Proposed Residential Development – Bricket Wood Sports And Country Club, Paintball Site & Bricket Lodge, Lye Lane, Bricket Wood, AL2 3TF

Technical Note

Prepared on behalf of JK Rudkin Builders Limited

June 2023

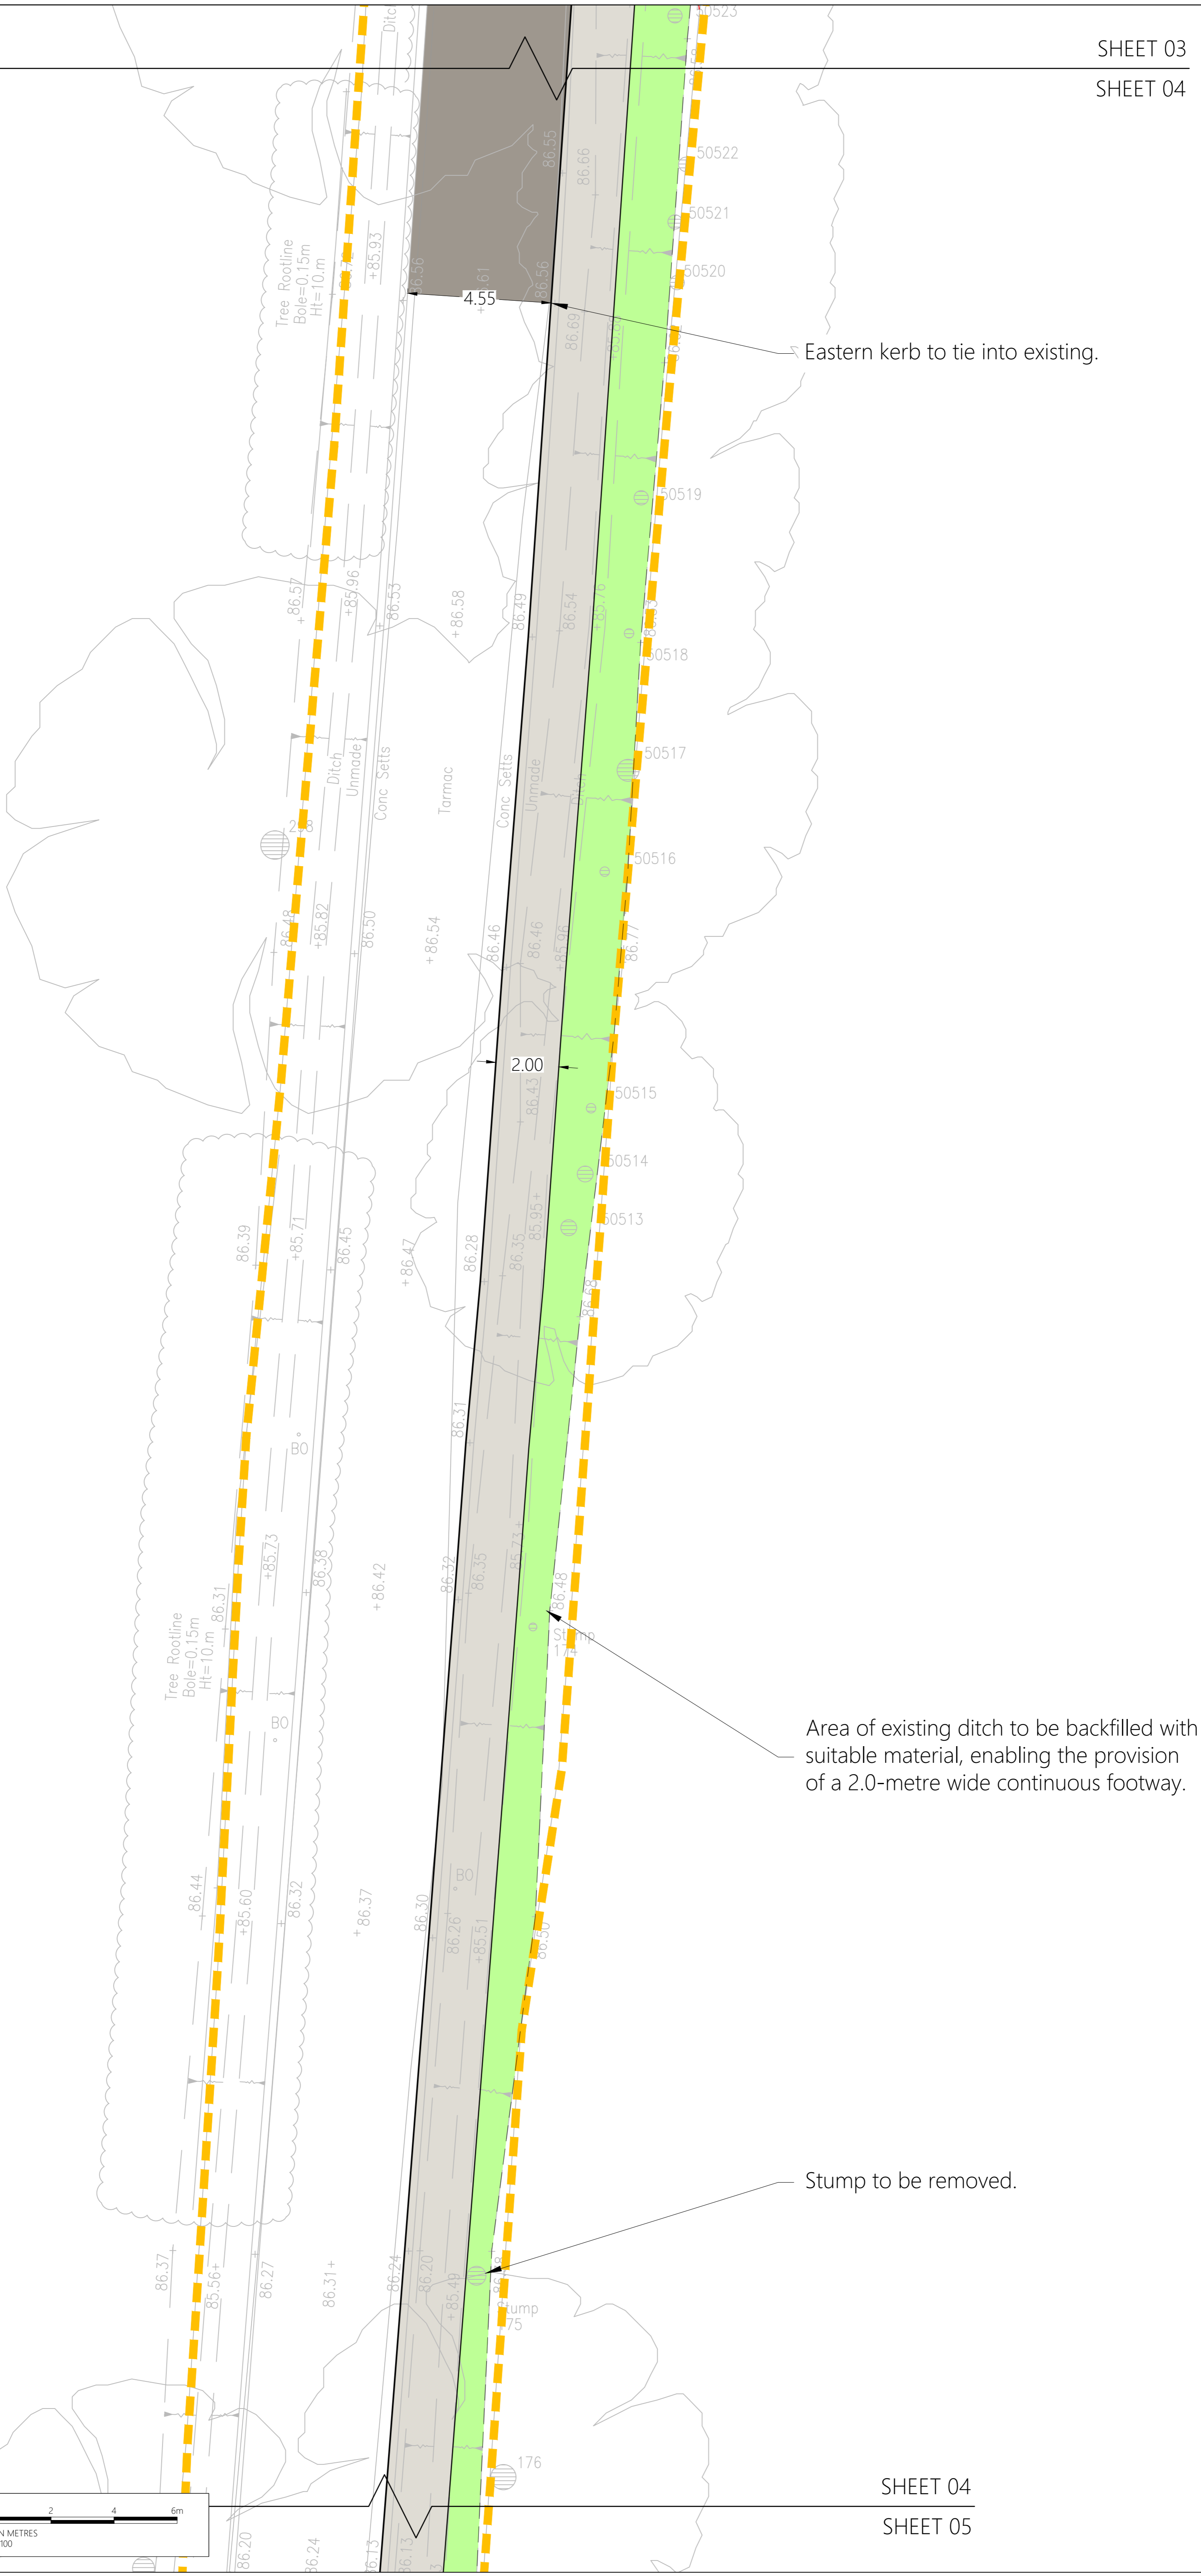
As detailed in Drawing No. 23051 / 001, sections of the existing ditches / gullies, that currently run adjacent to either side of the Lye Lane carriageway, will be backfilled with suitable material in order to enable the construction of the 2.0-metre wide footway. The suitable fill material will be topped with a minimum of 150mm topsoil and grass seed that will tie the proposed back edge of footway into the existing levels.

Area of existing ditch to be backfilled with suitable material, enabling the provision of a 2.0-metre wide continuous footway.

Stump to be removed.

Title
Proposed 'Active' Travel Improvements to Lye Lane (Sheet 5 of 7)

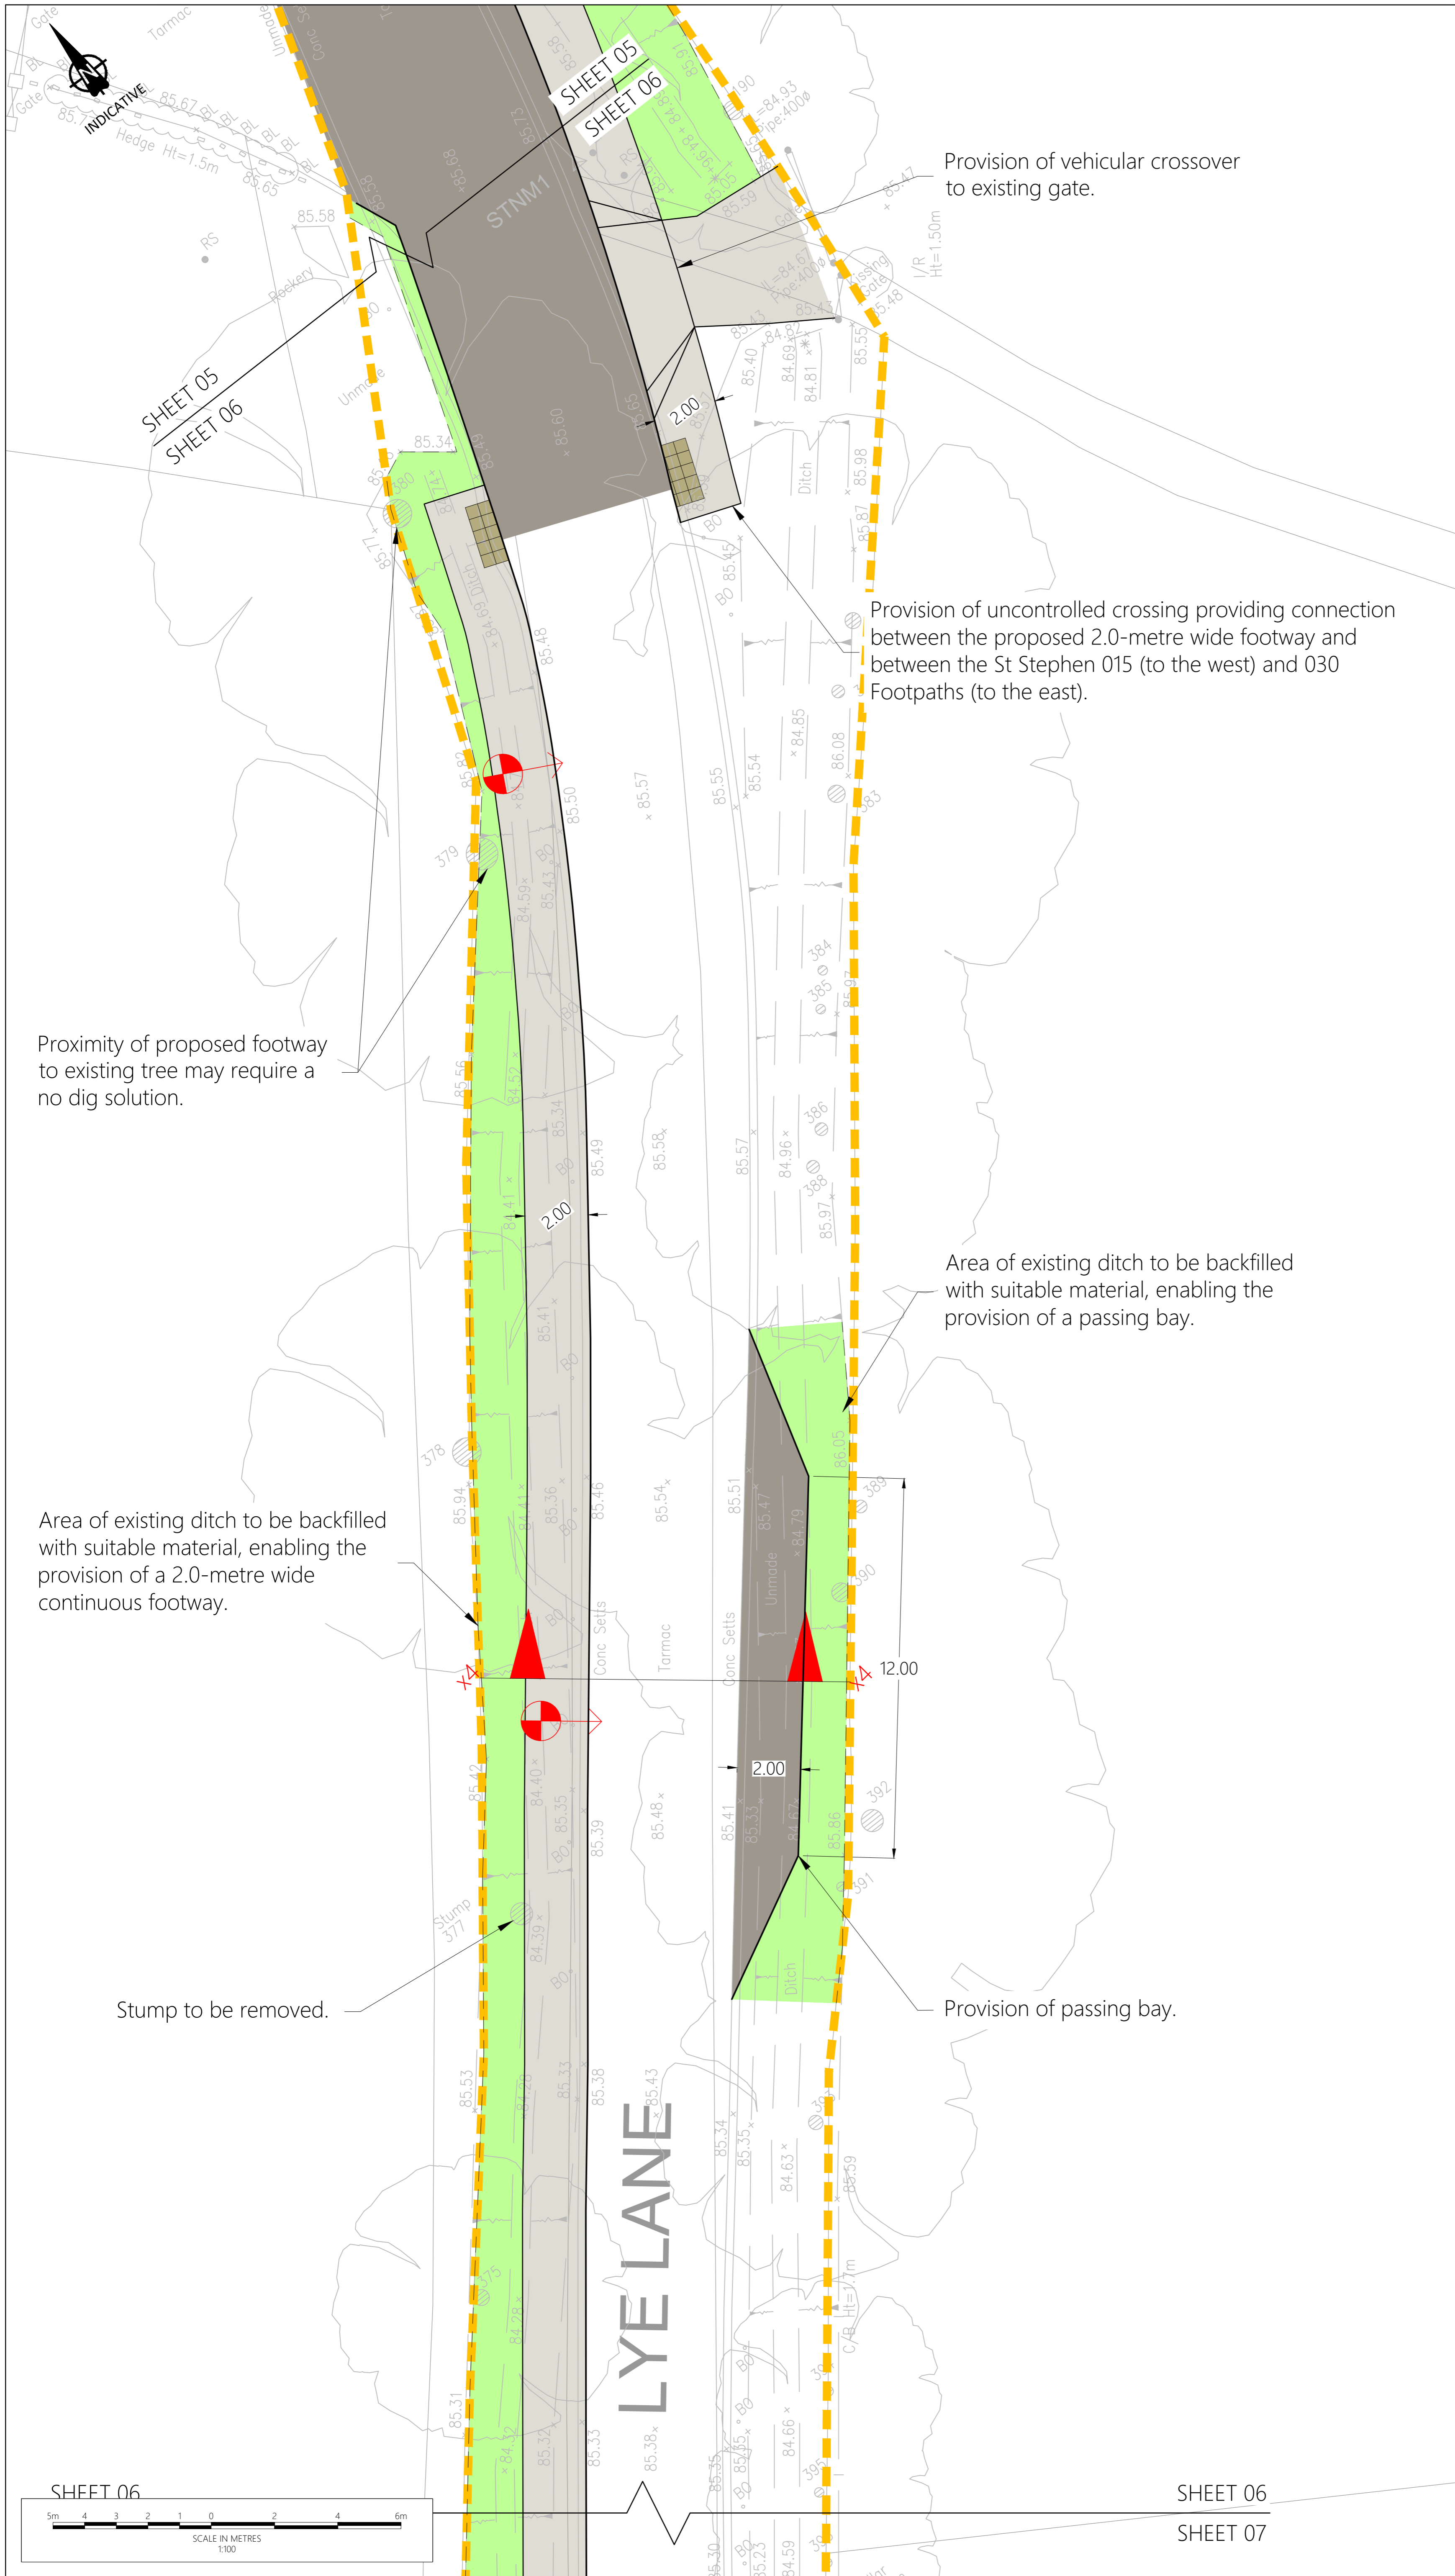
Finally, the Drawing No. 23051 / 001 reveals that the 2.0-metre wide footway, associated uncontrolled crossings, proposed Lye Lane carriageway realignment / widening, and proposed passing bay can all be fully accommodated within land under control of the applicant or the Highway Authority.

Area of existing ditch to be backfilled with suitable material, enabling the provision of a 2.0-metre wide continuous footway.

Provision of vehicular crossover to existing gate.

Provision of uncontrolled crossing providing connection between the proposed 2.0-metre wide footway and between the St Stephen 015 (to the west) and 030 Footpaths (to the east).

Area of existing ditch to be backfilled with suitable material, enabling the provision of a passing bay.

Title
Proposed 'Active' Travel Improvements to Lye Lane (Sheet 6 of 7)

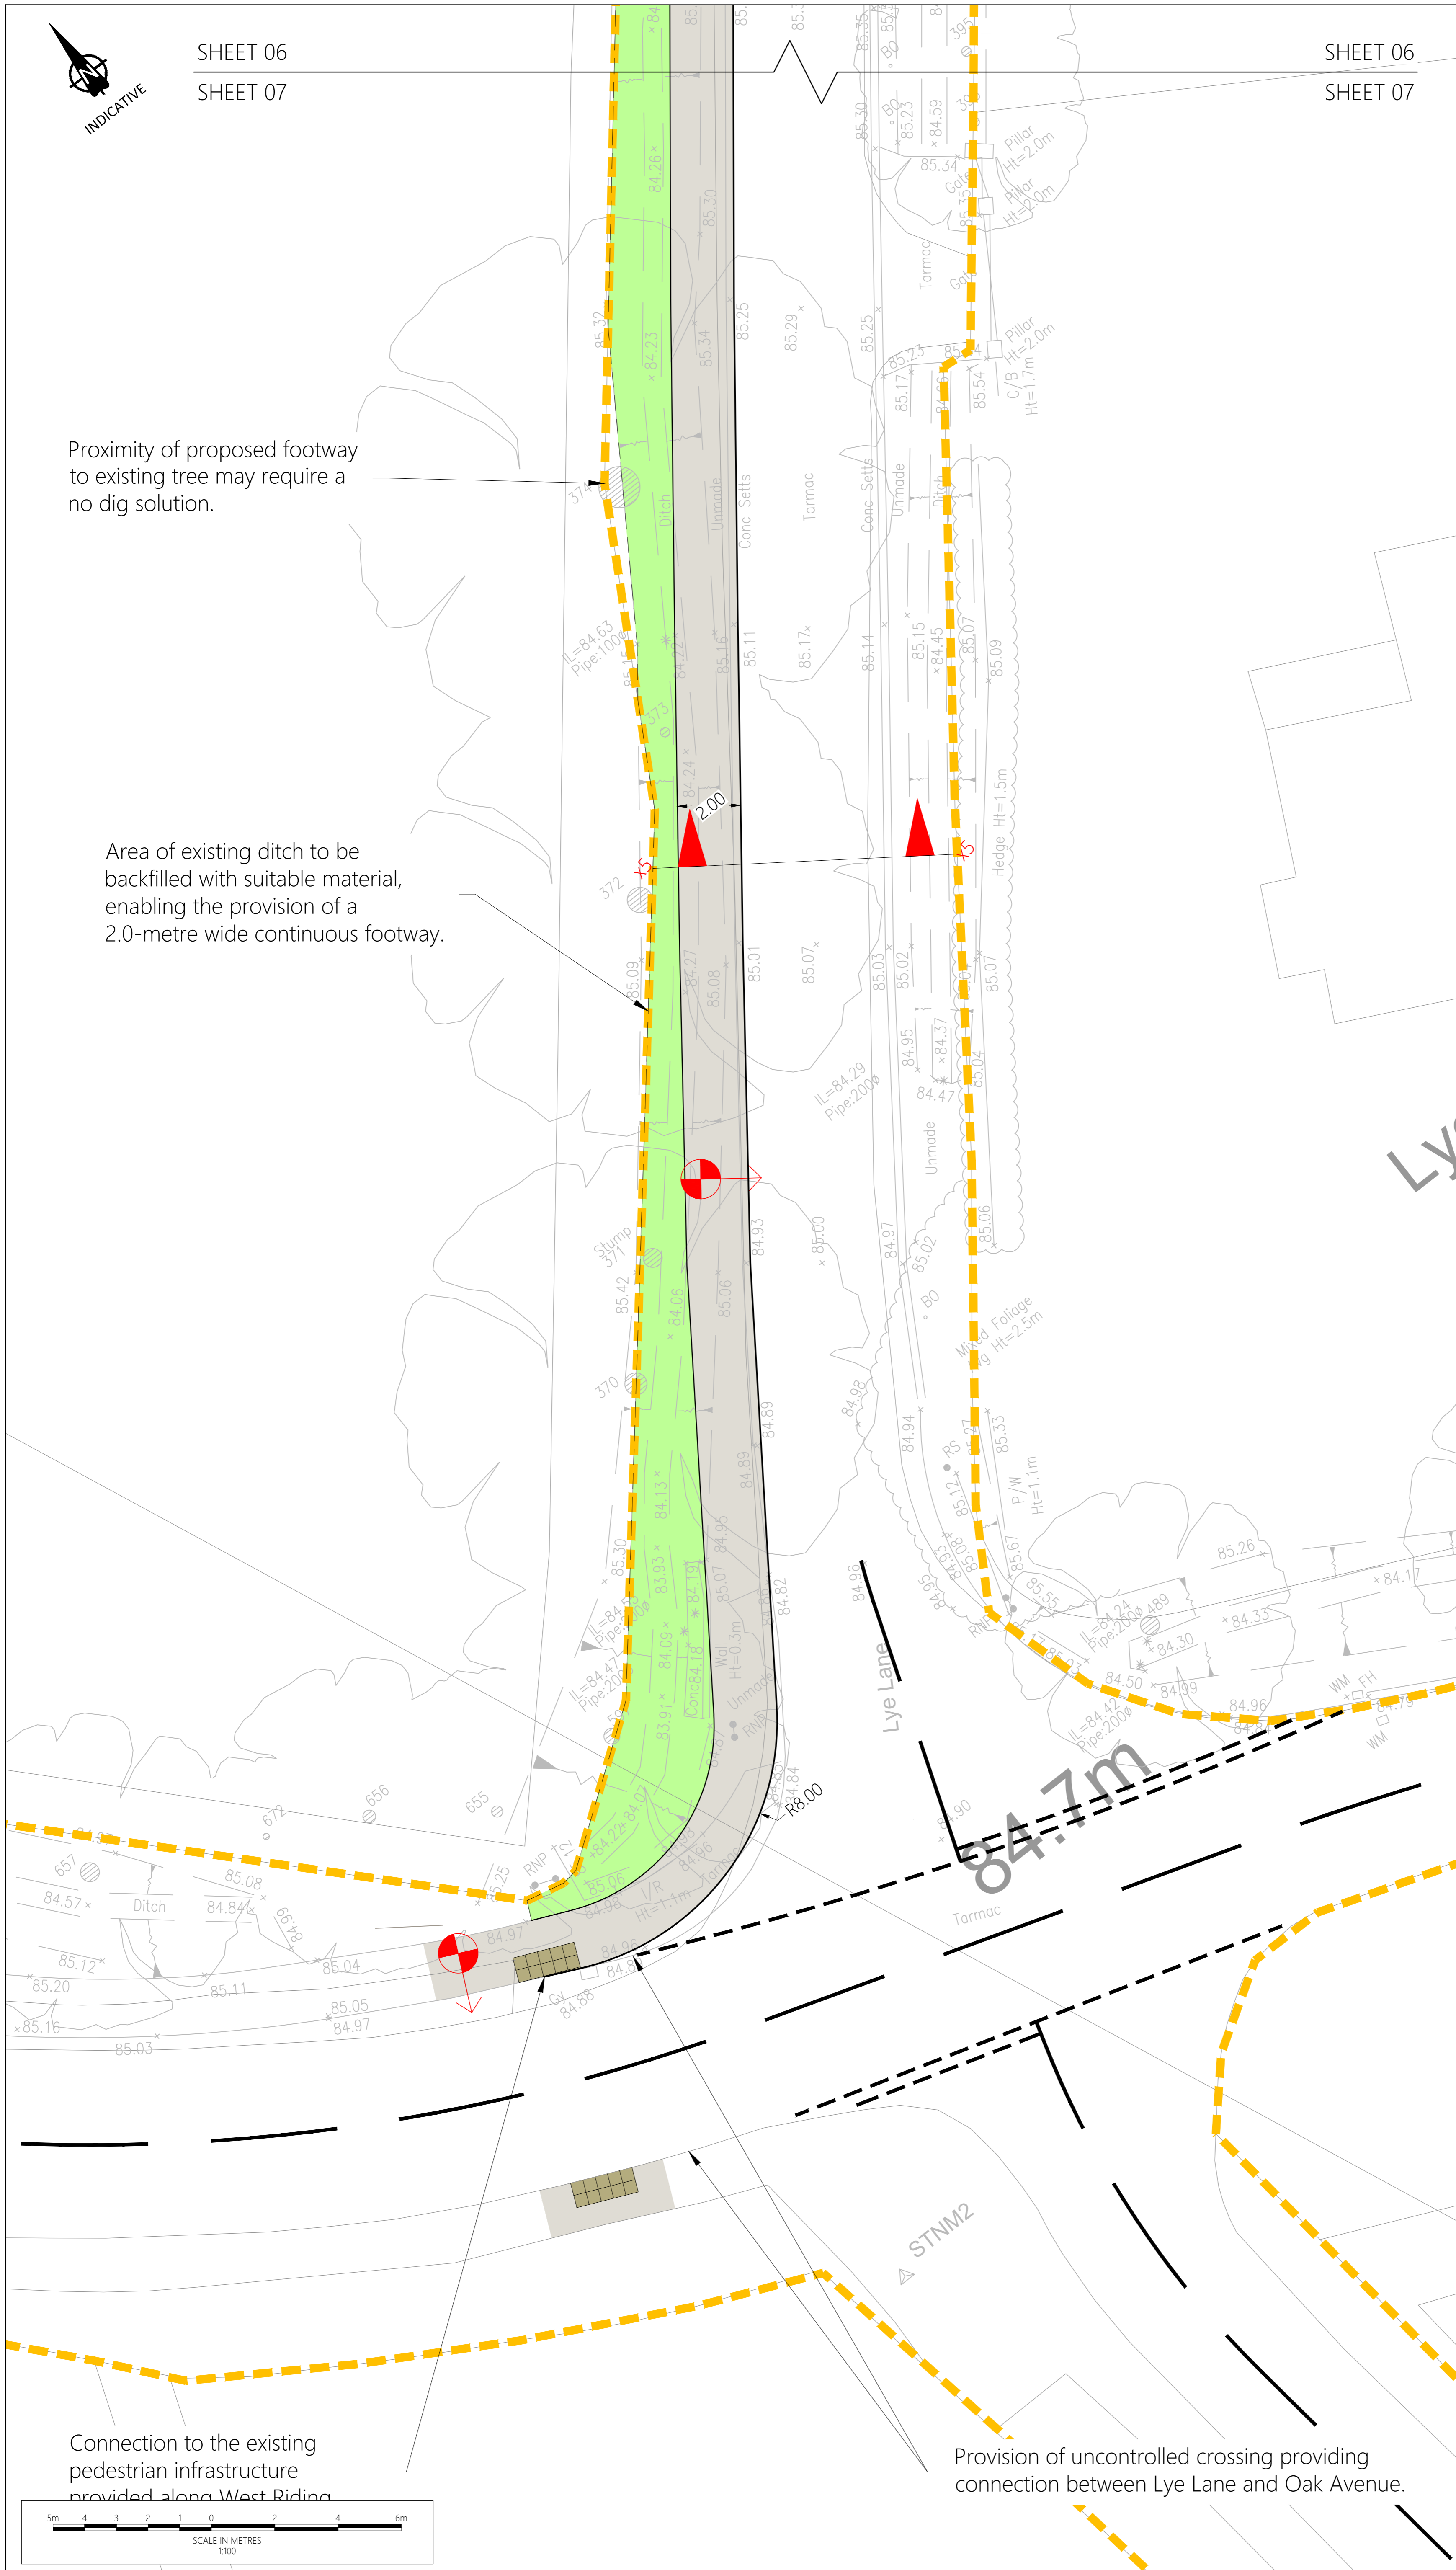
Drawing No. 23051 / 001, reveals that the 2.0-metre wide footway may require the selective removal of existing tree stumps. Of note, the footway has been designed so that no tree removal is proposed. Where the footway is in proximity to existing trees a no dig solution may be required during construction, this will be explored further during the Detailed Design stage.

Proximity of proposed footway to existing tree may require a no dig solution.

Area of existing ditch to be backfilled with suitable material, enabling the provision of a 2.0-metre wide continuous footway.
